Section 16 Application for Temporary Animal Boarding Establishment for a Period of 5 Years and Filling of Land at Lot 1185 S.E RP in D.D. 106, Kam Tin South, Yuen Long
(Planning Application No. A/YL-KTS/1009)

Submission of Further Information 1

Further Information 1

Responses-to-Comments

TITLE
FIRE SERVICE INSTALLATION LAYOUT PLAN

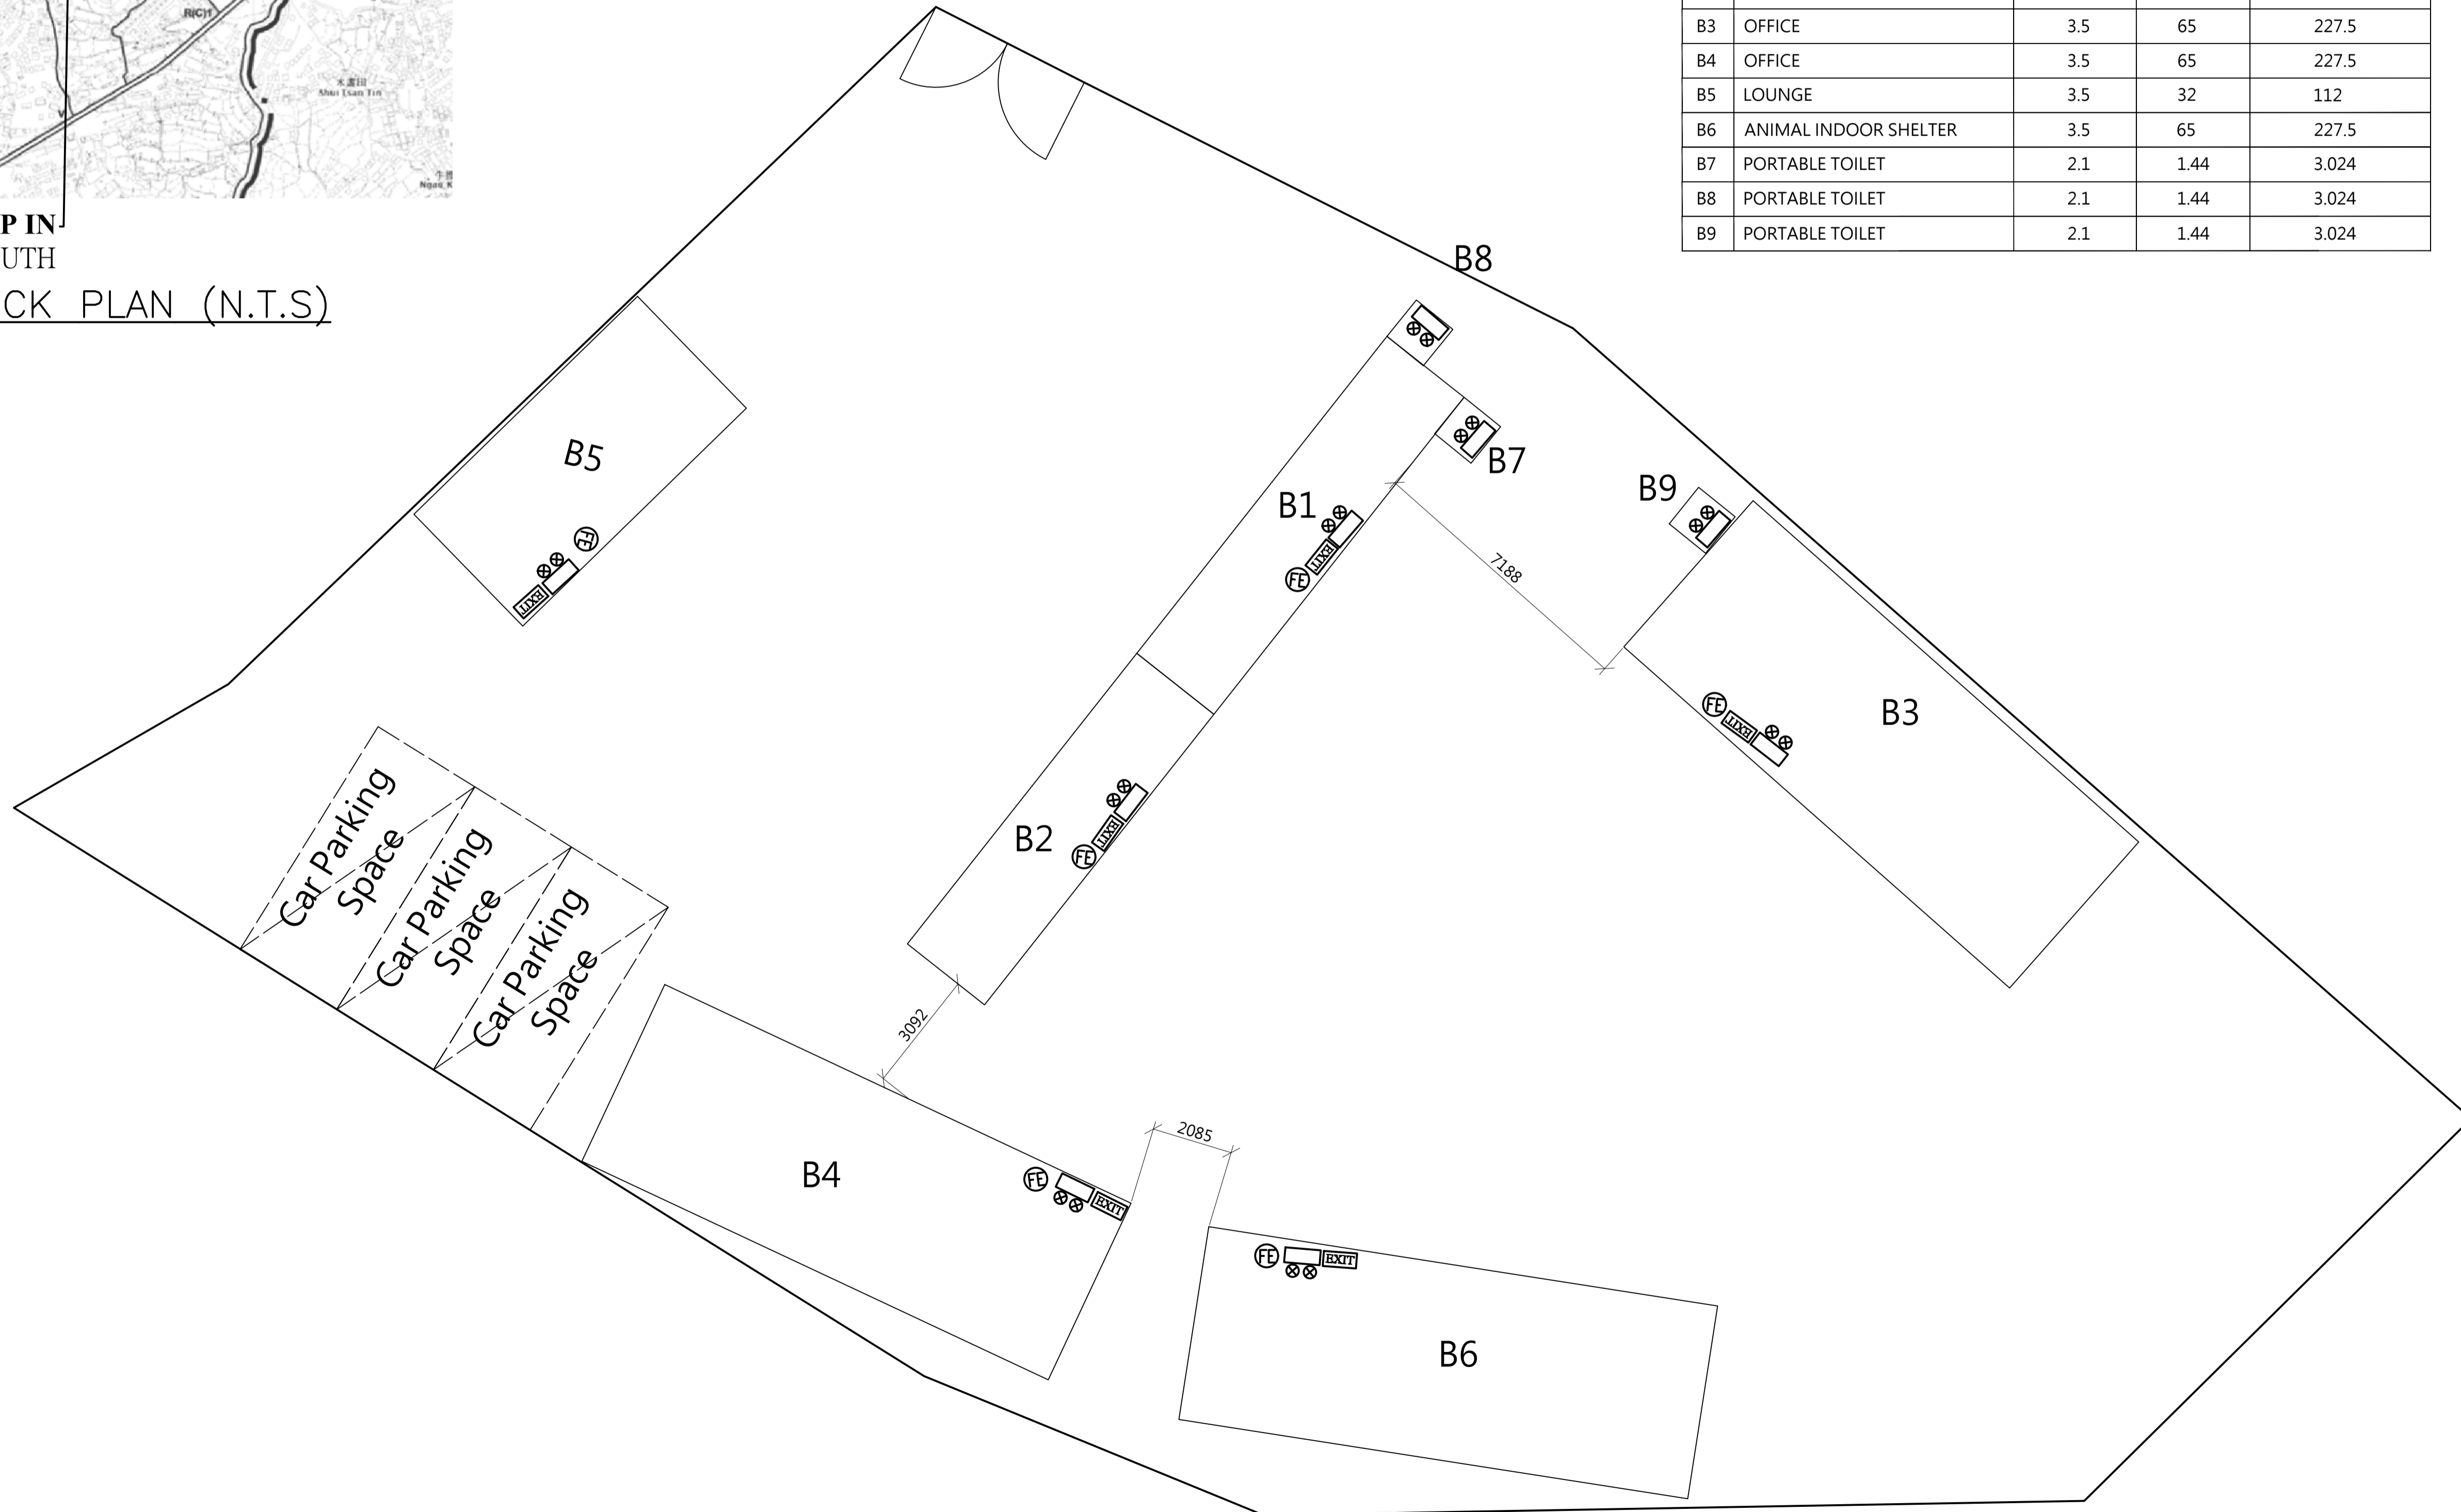
Item	Departmental Comments	Applicant's Responses																				
1. Comments from the Fire Services Department																						
1.	Based on the submitted FSI proposal, I have the following comments: i) The separation distance between each structure shall be clearly indicated on plan; and ii) In relation to i. above, structures on the same site are regarded as adjoining structures if they are less than 1.8 m apart. Additional FSIs (i.e. sprinkler system, modified hose reel system and fire alarm system) shall be provided if the total floor area exceeds 230m ² .	Noted. The separation distances between structures have been indicated on the revised plan (Annex 1 refers). Noted.																				
2. Comments from the Transport Department																						
1.	(a) The applicant should provide the trip generation and attraction due to the development and assess the traffic impact to Kam Shui South Road and the local access; and	Noted. Supplementary information of trip generation and attraction due to the development has been provided in the Table below, which echoes with Para. 4.3.4 and Table 4 of the Planning Statement that the peak hour traffic generation and attraction rate for Light Goods Vehicle shall be at most 3 vehicles. Hence, no adverse impacts on the surrounding road network, including Kam Shui South Road and the local access, shall be anticipated. Table of Estimated Trip Generation and Attraction

Annex 1
